PRELIMINARY BRIDGE SELECTION REPORT

**Sunset Road
Interstate 10 to River Rd**

Sunset Rd over Union Pacific Railroad (UPRR)

DESIGN & PLAN REVIEW COMMENTS

GENERAL PLAN
1" = 20"
New 2-Span AASHTO Type Super VI Modified Girders
Skew = 0° 00' 00"
Contour Interval = 1 ft.

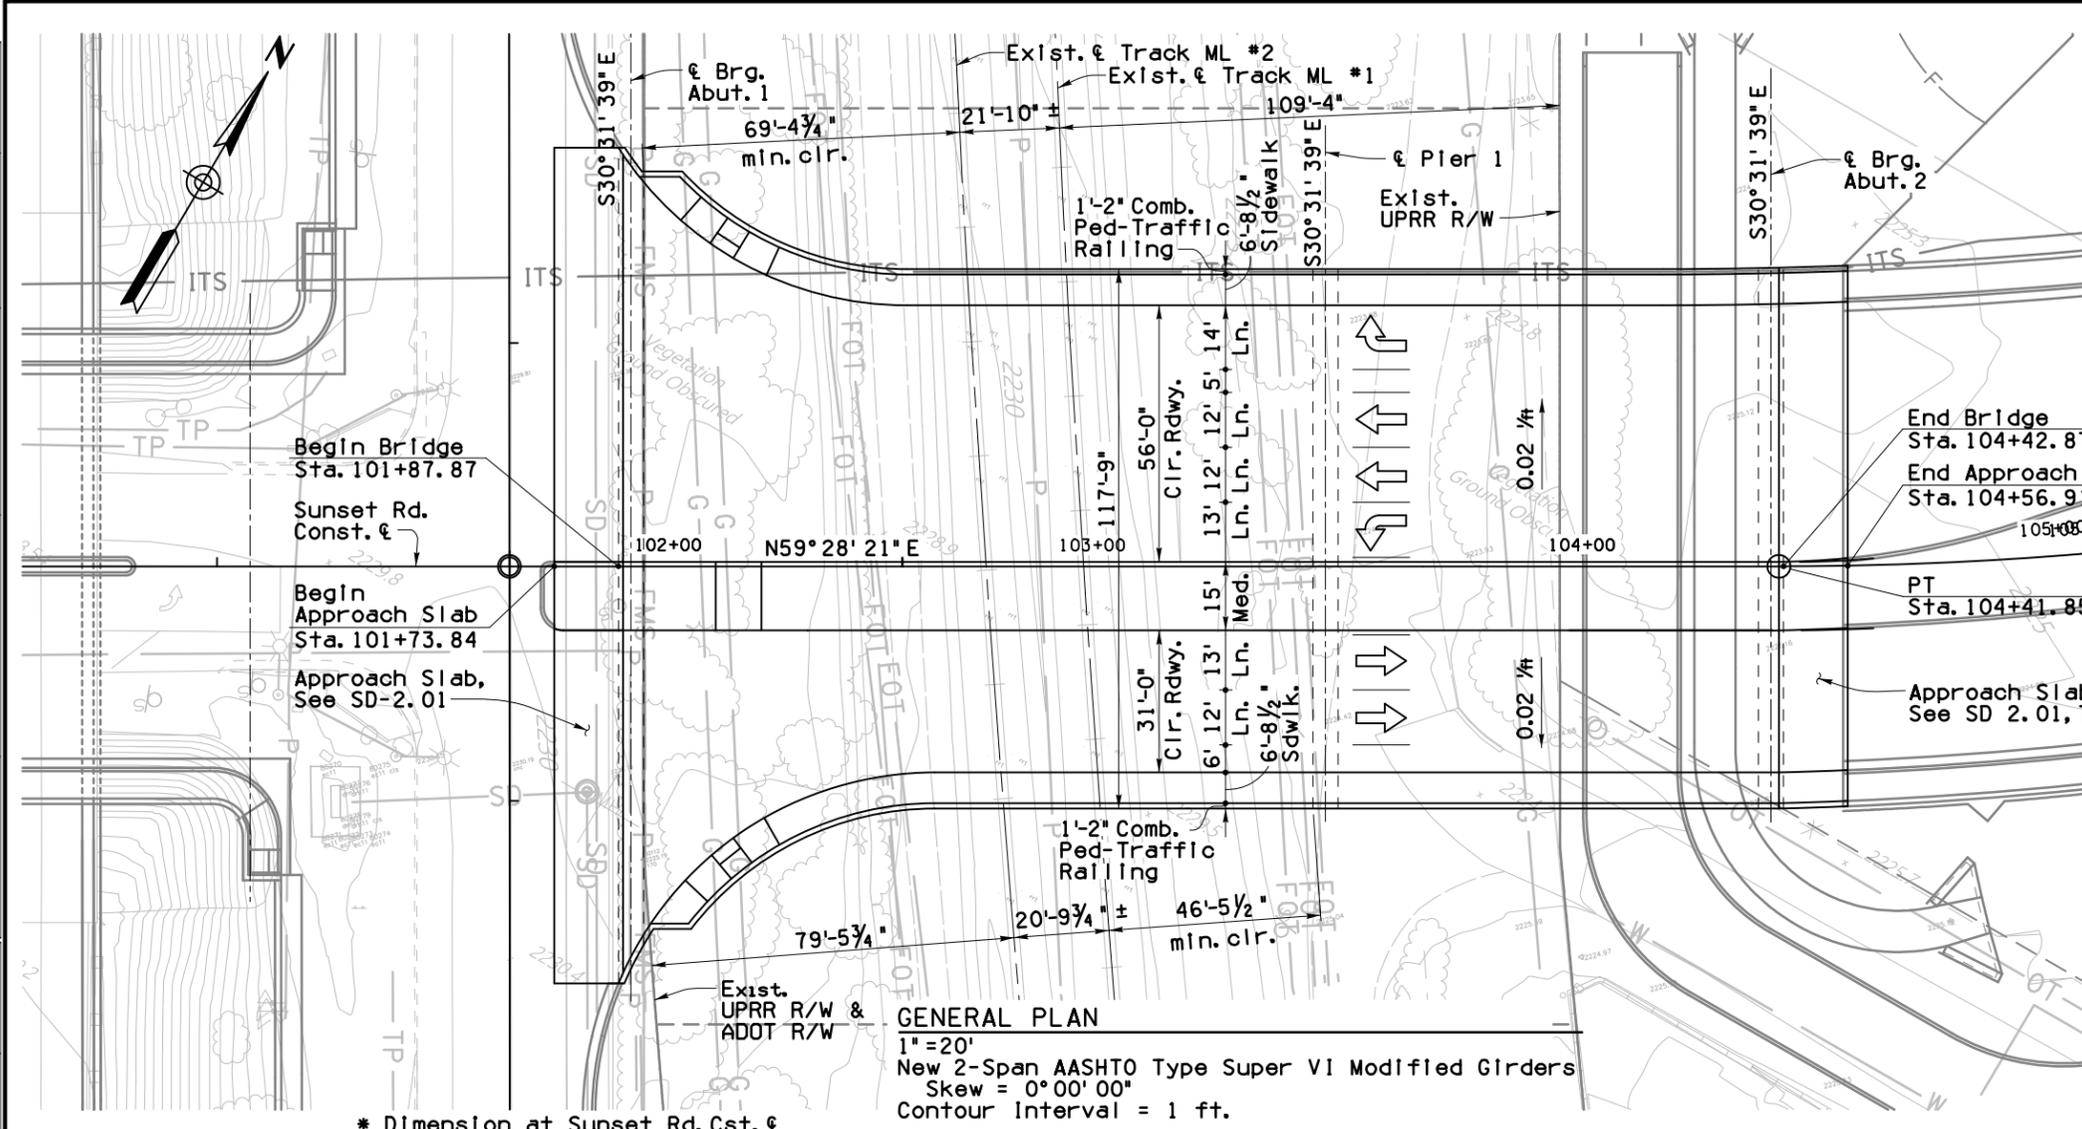
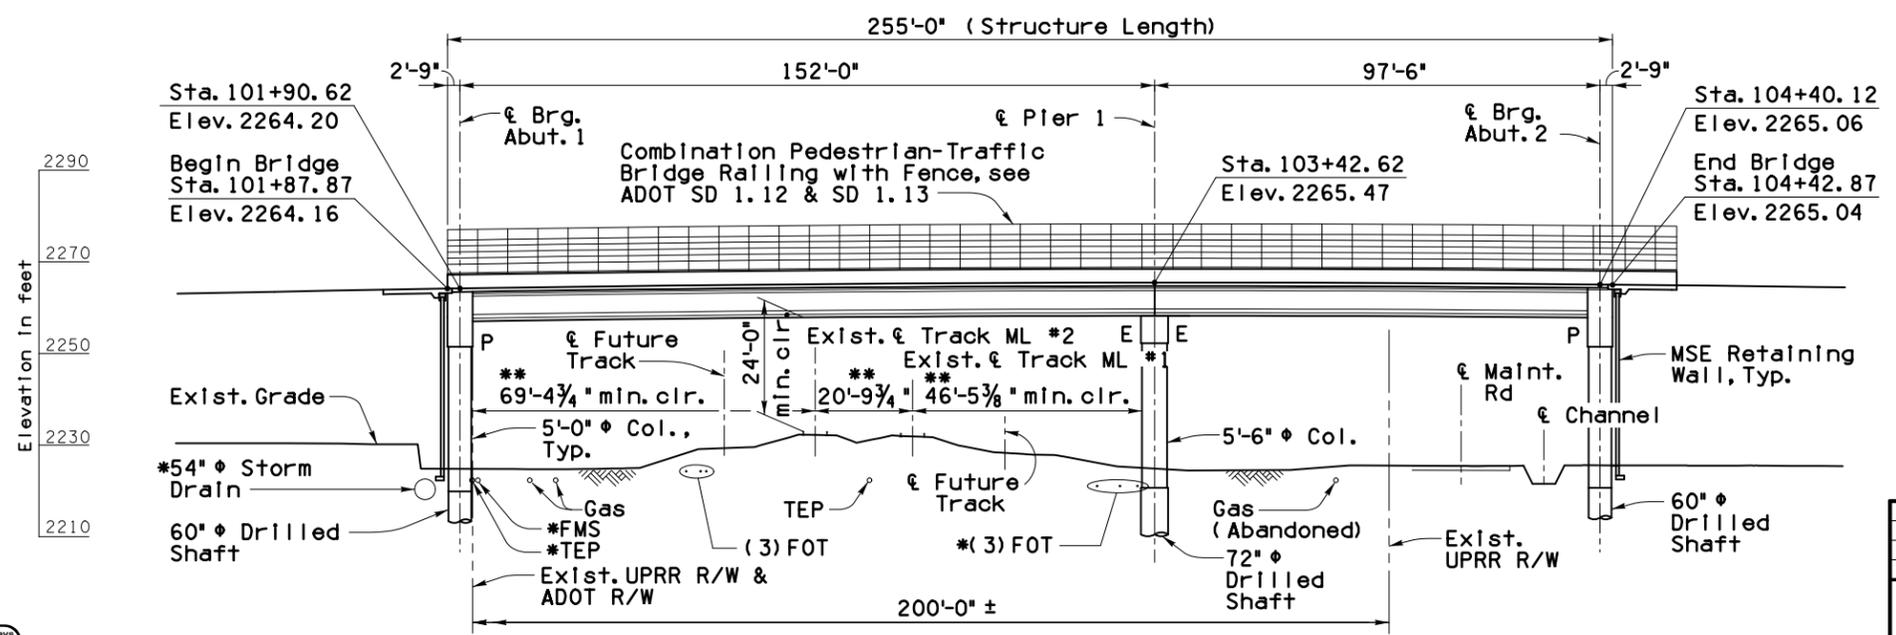
4.	Status	Alternative 3 proposes a substructure consisting of a pier located within UPRR Right-of-Way. Justification for such variance appears to be primarily economic in this case, which shall not be the determining factor as outlined in Section 3.2 and 4.1 of the UPRR/BNSF Guidelines for Railroad Grade Separation Projects. Since there is a feasible alternative that meets Art. 5.1c of the UPRR/BNSF Guidelines for Railroad Grade Separation Projects, the requested variance is not being considered. Consequently, current review status of Alternative 3 is 'REJECTED' .	TGM	Will modify	No further comment at this time.	TGM		Submittal Status

ARIZONA DEPARTMENT OF TRANSPORTATION INFRASTRUCTURE DELIVERY AND OPERATIONS DIVISION BRIDGE GROUP STANDARD DRAWING	
PEDESTRIAN FENCE FOR BRIDGE RAILING SD 1.12	DRAWING NO. SD 1.13

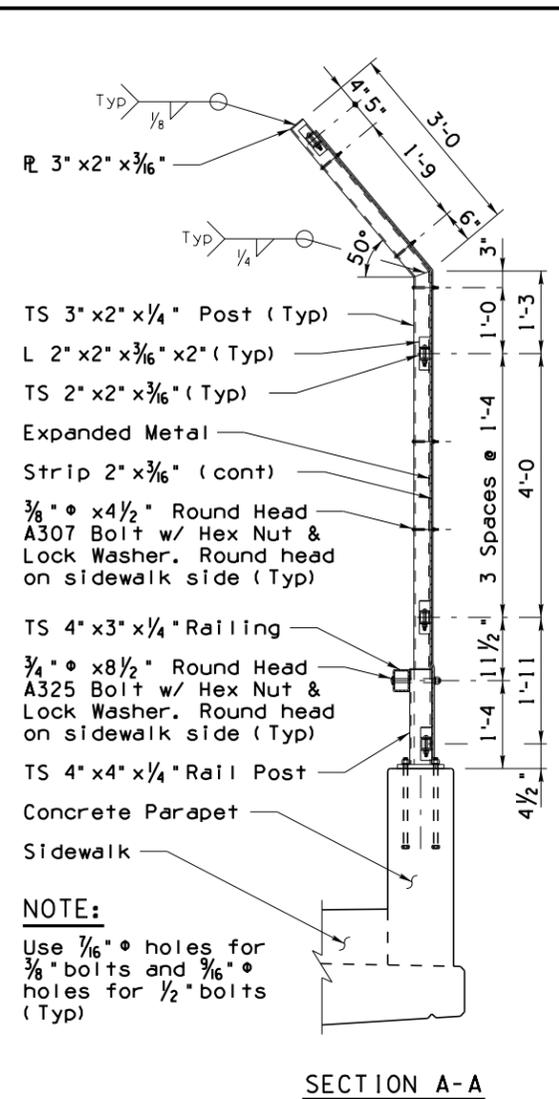
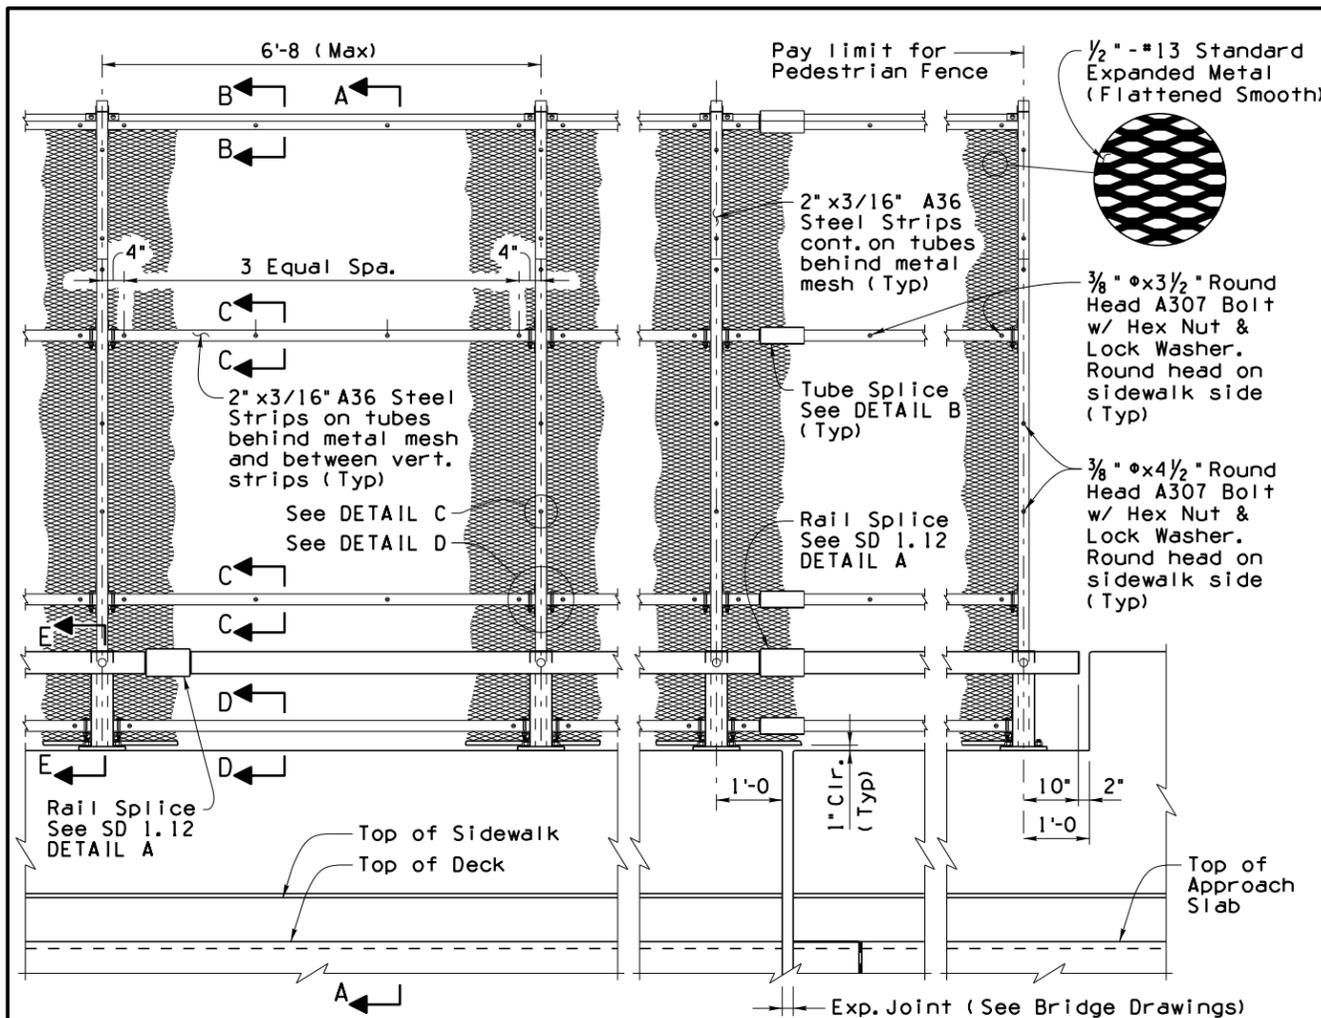
12.	General	Barriers and fencing shall be designed to meet the criteria of UPRR STD Plan No. 711100 Sheet 3 and Section 5.4 of the UPRR/BNSF Guidelines for Railroad Grade Separation Projects. Note, barriers shall be designed to keep the bridge deck's storm water runoff from being deposited onto UPRR ROW, as outlined in Art. 5.4b(1) of the UPRR/BNSF Guidelines for Railroad Grade Separation Projects.	TGM	Barriers and fencing called out meet the UPRR criteria	The "Combination Pedestrian-Traffic Bridge Railing w/ Fence" callouts on p. 14 of 27 reference SD 1.12 & SD 1.13, which do not appear to be included with this submittal. Please provide dimensions and details showing compliance with the 07/22/20 comment. This comment will remain open for review at the next milestone submittal.	TGM	SD 1.12 and SD 1.13 are attached.	Open
